Wiltshire Council Planning Consultation Response

URBAN DESIGN

Application No: PL/2026/00347

Proposal: Approval of Reserved Matters (Appearance, Landscaping, Layout and Scale) Following Outline Planning Permission PL/2022/02452 for 140 Dwellings, a Habitat Support Area and Associated Landscaping and

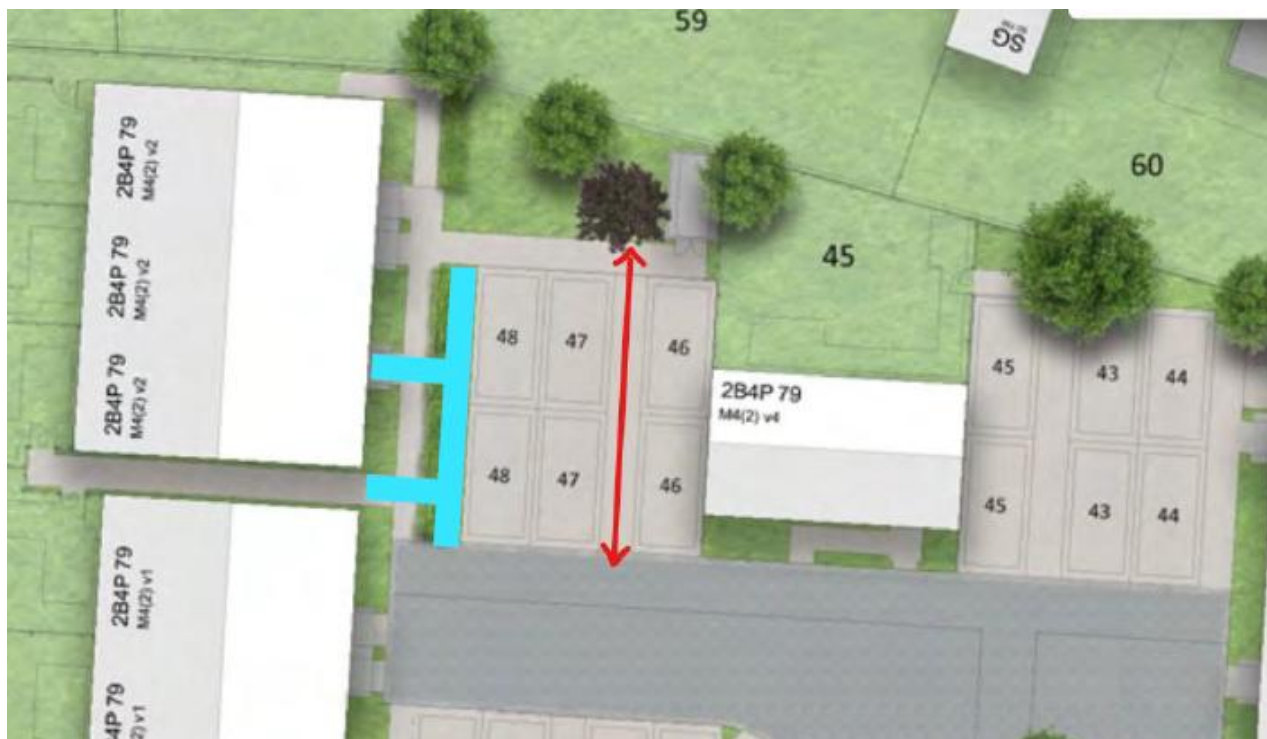
The rear garden of plot 108 and of plot 123 would not meet WDG expectation 9.2.4 that these should create usable garden shapes avoiding irregular pointed corners and narrow strips.

- ✓ It is acknowledged that these plots have been amended where possible.
